## Reply to Referee #1

Wenlong Wang on behalf of all co-authors

The manuscript entitled “Spatial-temporal changes in flow hydraulic characteristics and soil loss during gully headcut erosion” is a study of gully head evolution under controlled conditions belonging to a set of papers presented by the authors in the last years on this subject. Since the authors aim in this manuscript is to investigate the hydraulics changes in the flow through the gully and its impact on energy consumption it fits into the journal scope. My general comments on the manuscript are that it covers a topic of interest, and it is well structured with clear Tables and Figures. Not been a native English speaker I find hard to suggest specific changes in the English usage, but there are sections that are hard to follow and expressions that does not seem the most appropriate (e.g. line 146 “artificially planted forest: : :”). In my opinion the most valuable part of the manuscript is the experimental dataset presented by the authors, which are scarce in gully erosion studies. However, the results are mostly a confirmation of the previous knowledge, some hardly novel like the transition in hydraulic regime tro

Fig. 1 Variations in total energy consumption and rest flow energy with flow discharge and their ratios to total energy

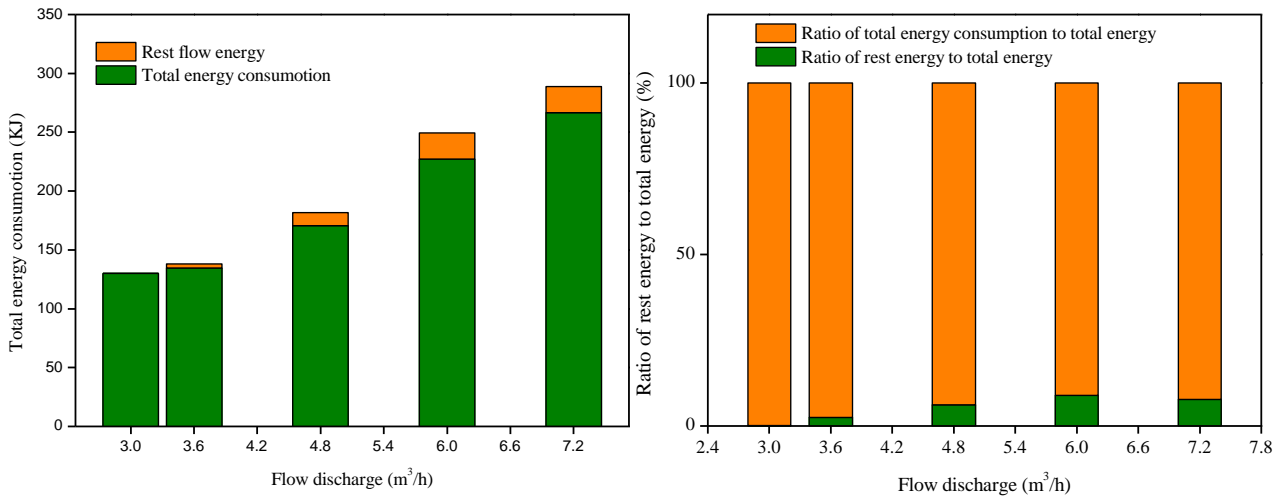
**Q3.** 3- The analysis of energy dissipation does not seem in depth enough. Firstly, there is no attempt to provide an overall energy analysis of the system, there are energy losses in the water depth which are not mentioned (like the one dissipated as heat and noise) and it is not clear how much of the original energy available to the flow (which I guess is the potential energy at the reservoir located

at the top of the upstream section) is dissipated and how much remains at the end of the flume. The authors do not try to analyze the results to seek if some kind of optimization of energy dissipation (as suggested by previous papers on river and rill network development) is apparent. For instance calculating the energy losses by wetted section or by unit flow or sediment discharge, like previous studies. These are ideas, among others in that line, that the authors may want to explore to take advantage of the very detailed dataset that they have developed.

**Response:** We fully agree with your comment. Indeed, we have not provided the overall energy analysis of the system in the original submission. As you guessed, the original energy available to flow is the potential energy based on the zero-potential surface (the bottom of the gully bed section), which was calculated by Eq. (9). We will add the analysis about the “how much of the original energy available to the flow is dissipated and how much remains at the end of the flume”. The following figure shows the total flow energy, total energy consumption and the rest flow energy under different flow discharge conditions. The added Fig. 1 will combine with Figure 10 in “3.2 Spatial-temporal change of energy consumption”.

Fig. 4 Temporal change in sediment concentration of upstream area and flume outlet

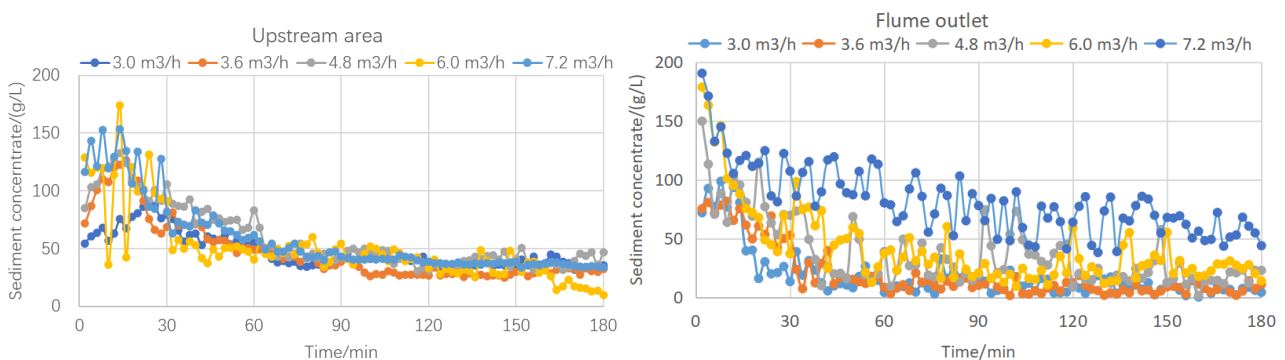
**Q13.** 9- Discussion on soil losses. A mention of the sediment concentration measured in the upstream and flume outlet might be quite helpful to understand the erosion/deposition processes.

**Response:** We are particularly grateful to you for your valuable suggestions on the revision of our manuscript. As you mentioned, we indeed measured/calculated the sediment concentration of upstream area and flume outlet. The sediment concentration of upstream area and flume outlet was showed as following figures (Fig. 4) under different flow discharge conditions. In fact, the sediment concentration of flume outlet can reflect the erosion process of the “upstream area - gully head – gully bed” system. Compared with the soil loss process of the upstream area and the system (Figure 11a, 11b), we found the change in sediment concentration with time is consistent with the temporal change of soil loss rate. Moreover, in Figure 11, we exhibited the soil loss/deposition process of three landform units as well as the “upstream area - gully head – gully bed” system, which can reflect the erosion/deposition process of each landform unit.

We also think the mention of sediment concentration is worth adding. However, given this similar change trend between soil loss process and sediment concentration process, we carefully considered and decided not to add it in the results section. Of course, We respect the suggestions of reviewers very much, and thus, we will add some related discussion in Discussion section about soil losses.
